MEMORANDUM

TO: Planning Board Members
FROM: Michael A. Lumbis, Planning and Community Development Director
SUBJECT: Site Plan Approval – 1851 State Street
DATE: August 31, 2022
Request: Site Plan Approval for the construction of a drive-thru Internet Teller Machine, interior asphalt loop, and related site improvements at 1851 State Street, Parcel Number 5-21-122.200
Applicant: Kurt Hackwelder, RLA, of Otisco Design on behalf of Northern Credit Union
Proposed Use: Drive-thru Internet Teller Machine
Property Owners: Northern Credit Union

Re: Site Plan Approval Application – Cover Letter
Northern Credit Union Drive-thru Development – 1851 State Street

B2 GENERAL SITE PLAN
1" = 50'

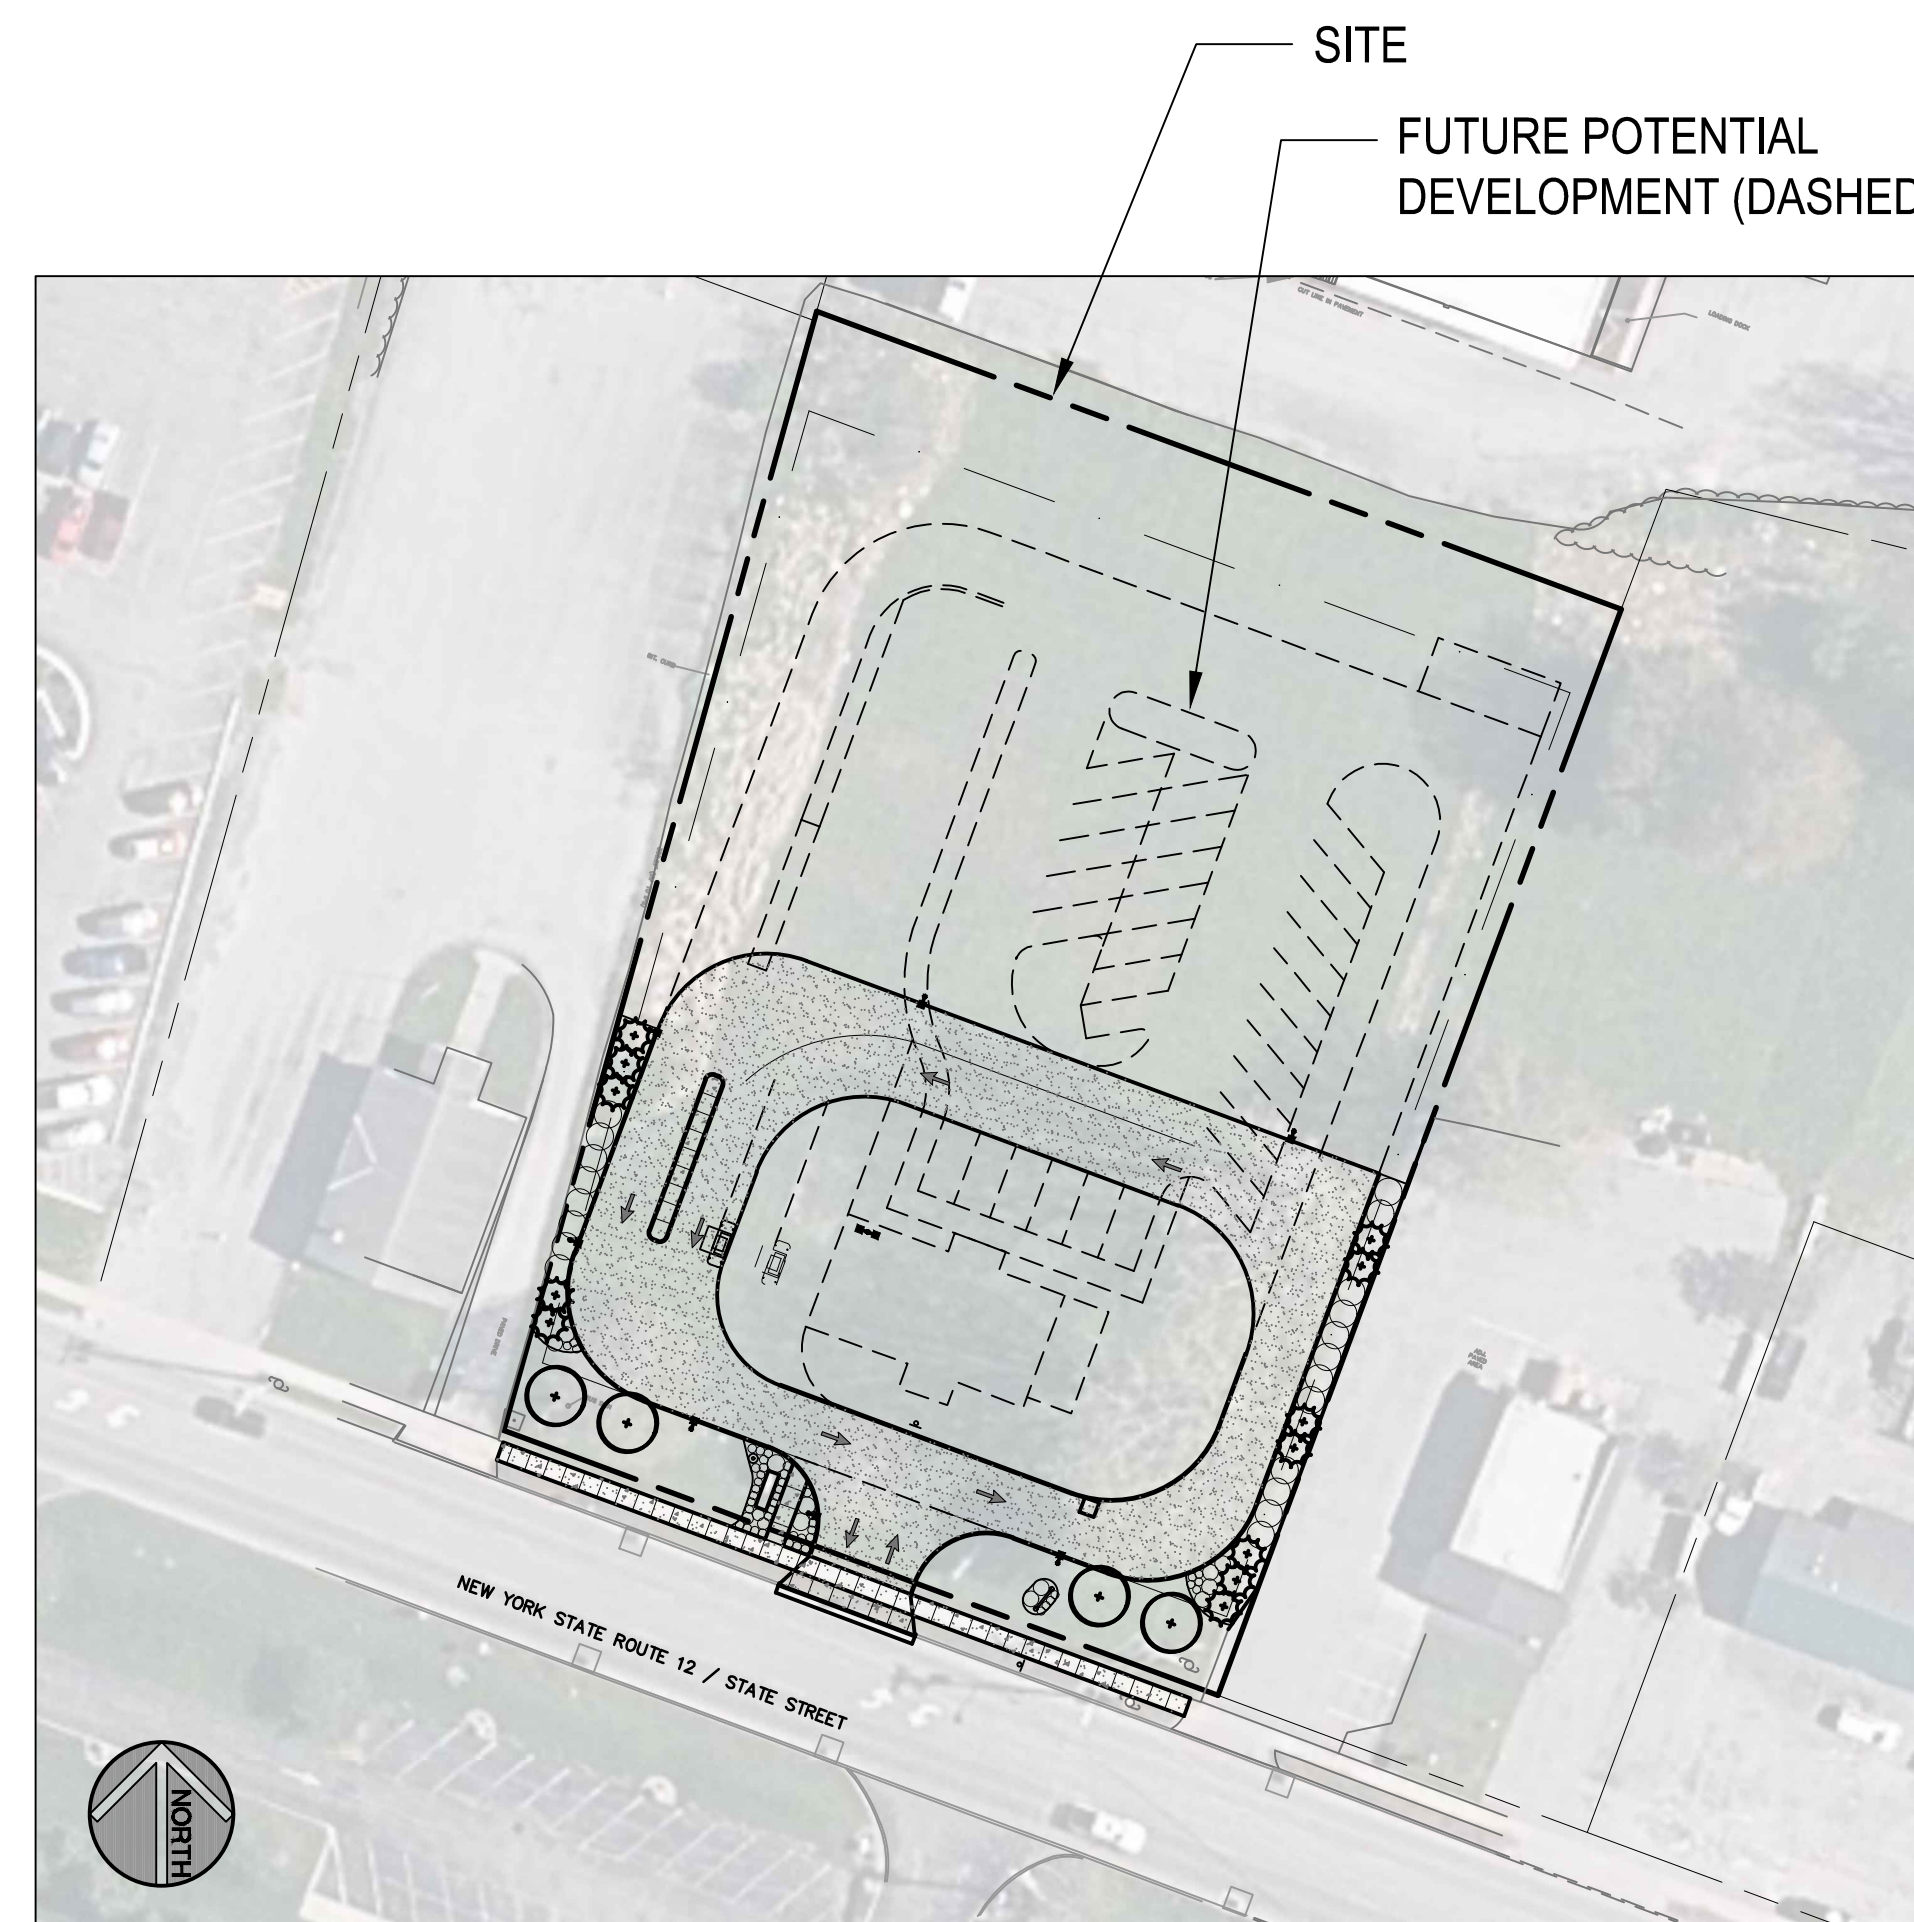
Other: The general site plan on the cover sheet shows future potential development consisting of a building, parking and other site development. Any future construction at the site will require site plan review and approval.

SITE LIGHTING
PHOTOMETRIC PLAN

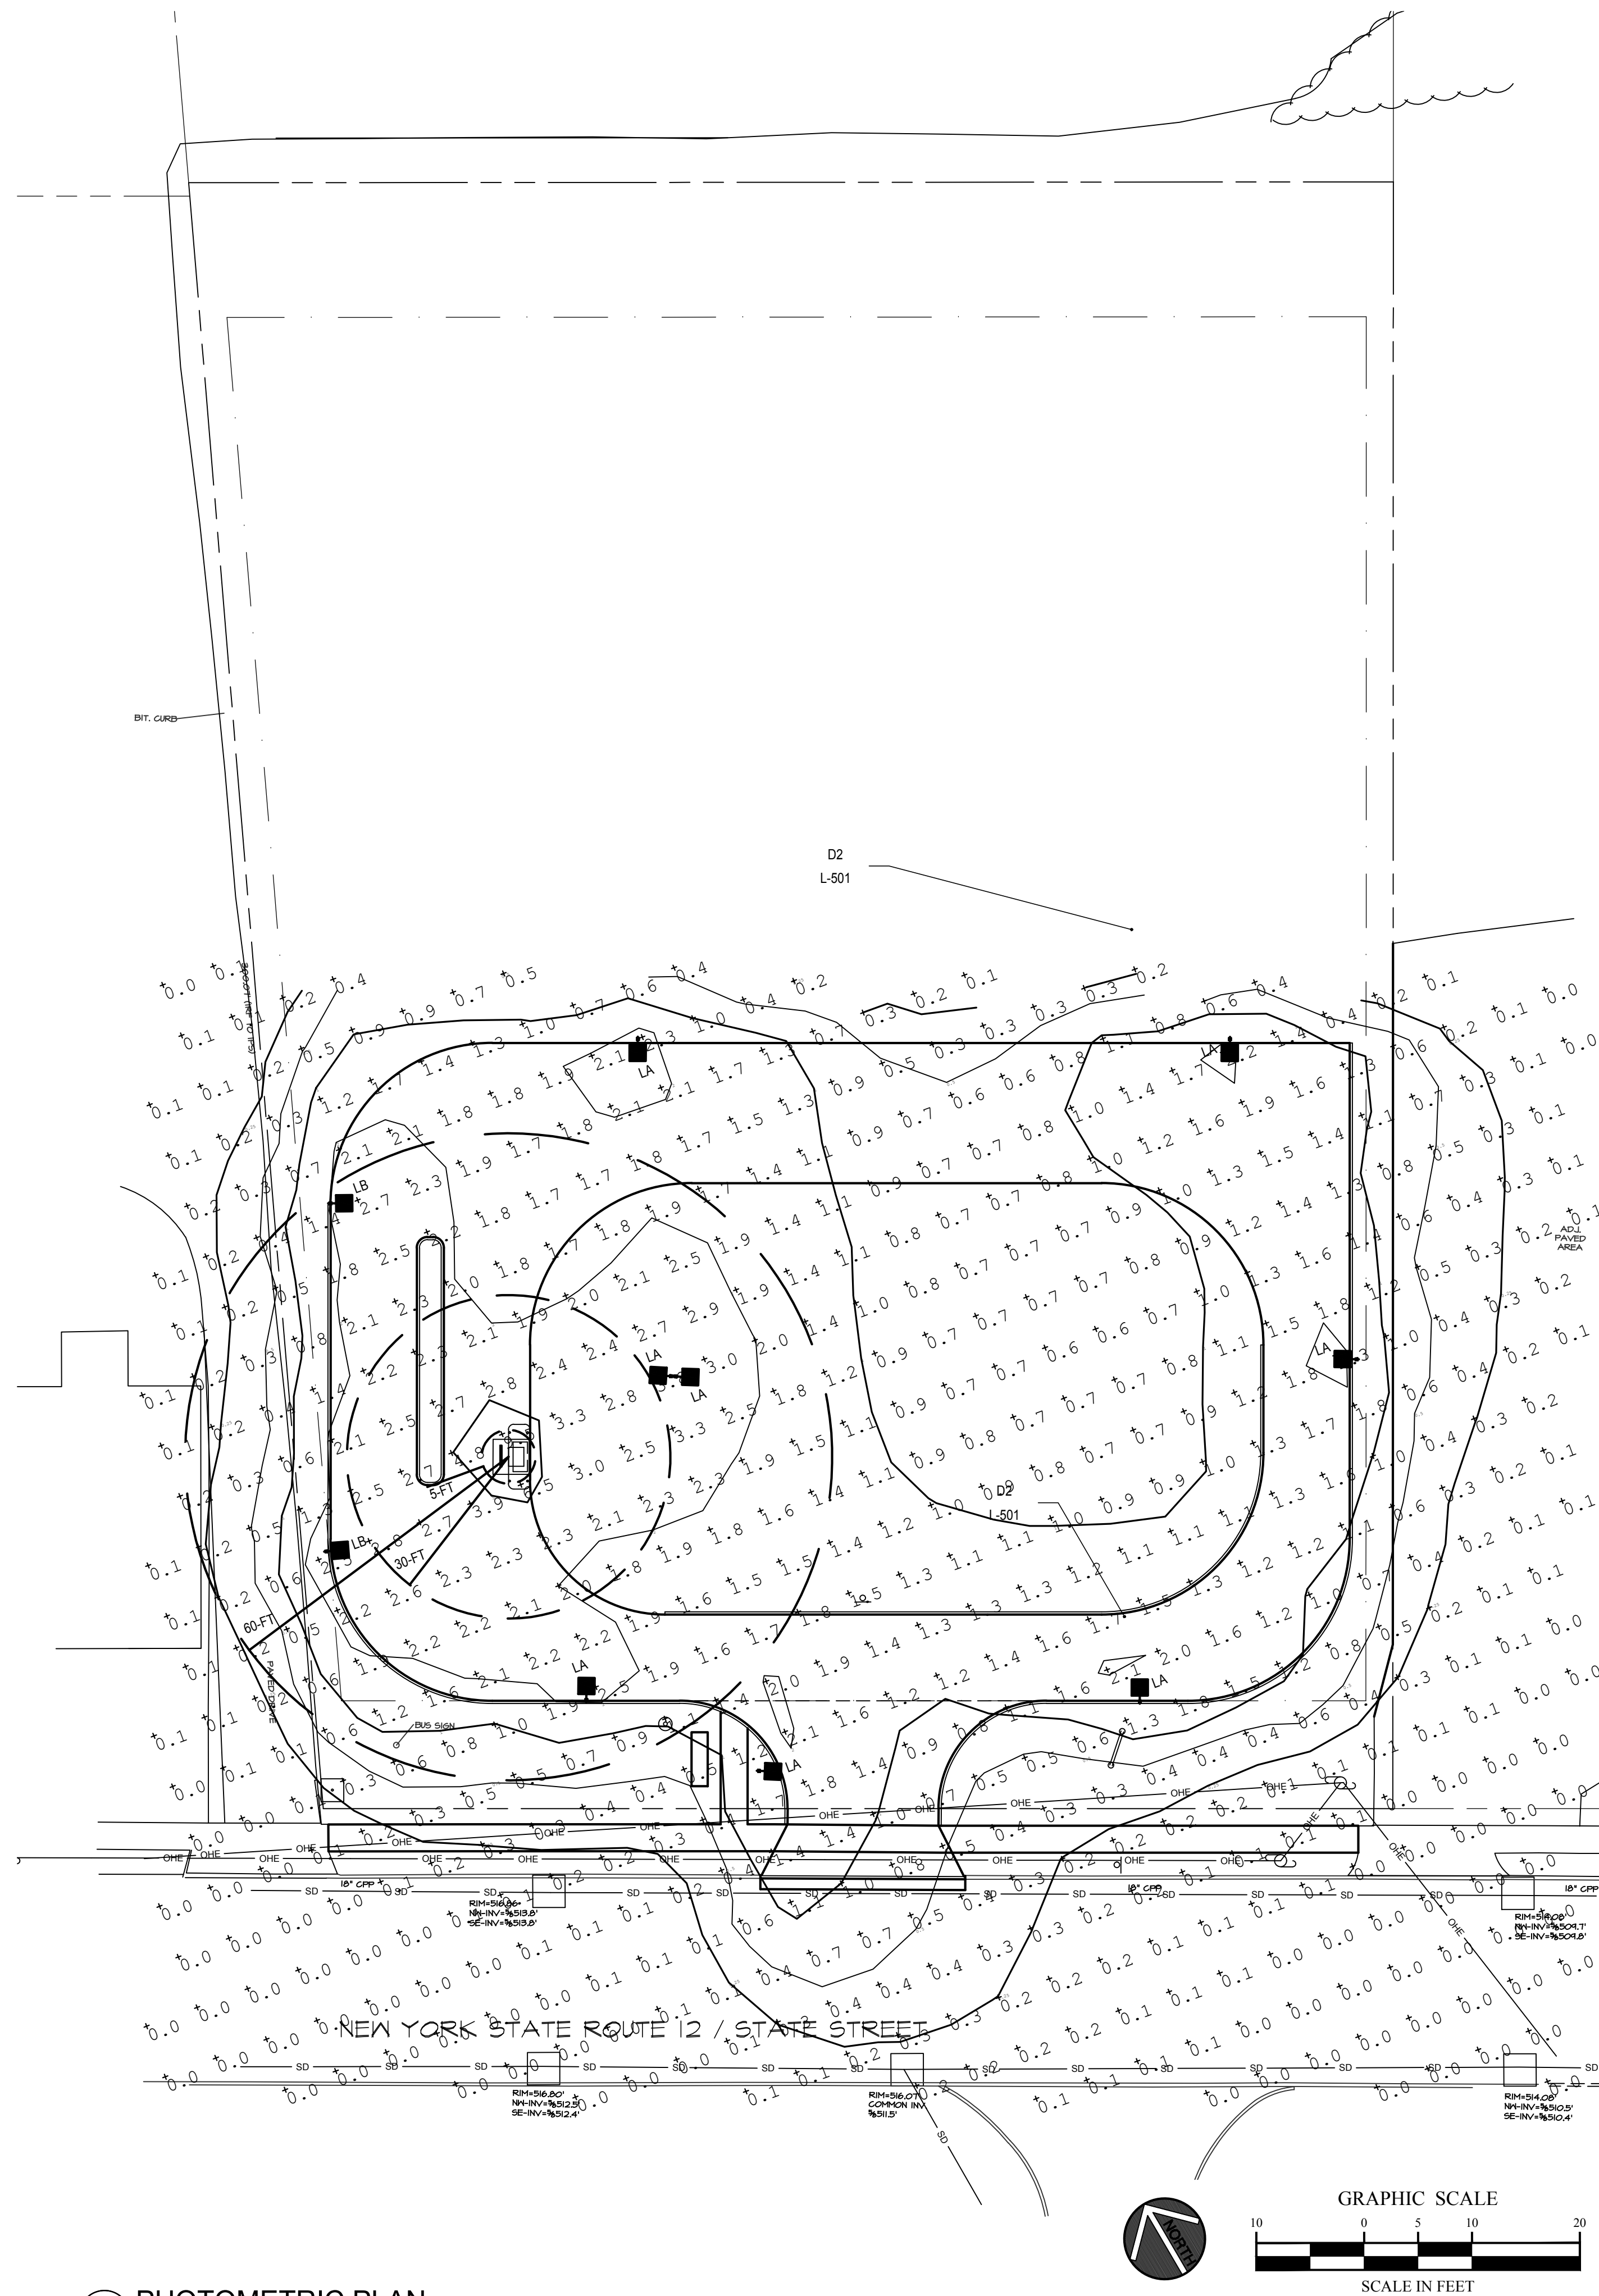
Lighting: Currently this site does not have any internal lighting but receives minimal light overflow from a streetlight located at the southeast corner of the parcel. The applicant proposes to install eight (8) new light poles and nine (9) LED fixtures, although there is no information provided regarding the style or height of the fixtures. A photometric plan was included with the application which shows that light spillage across the property lines will be minimal.

Monument Sign

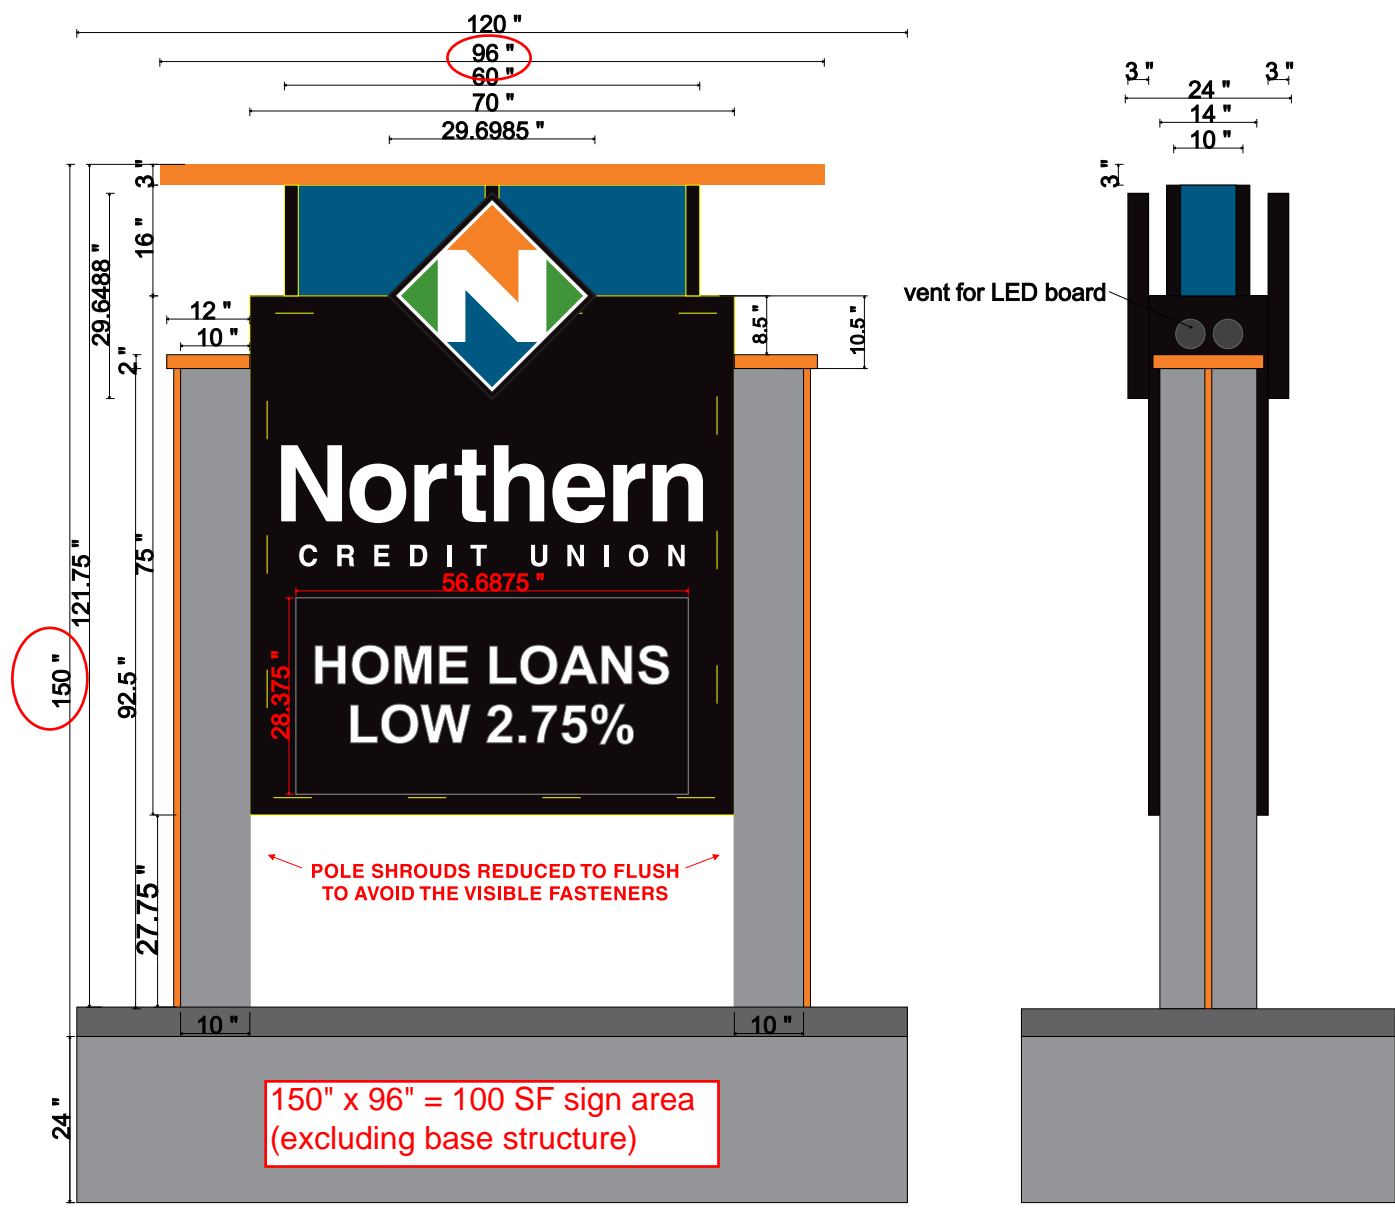
Signage: The applicant is proposing a new monument sign near the entrance/exit. The proposed signage will not be approved as part of the site plan approval process. The applicant will need to apply for a separate sign permit prior to the installation of the sign.

It should be noted that the allowed sign surface area for a parcel is based on the linear feet of building frontage. In this case, there is no building frontage except for the ITM. Depending on the proposed size of the sign, the applicant/owner may need to apply for an area variance to exceed the allowed sign surface area. Staff will work with the applicant/owner to make this determination and assist with any other necessary applications.
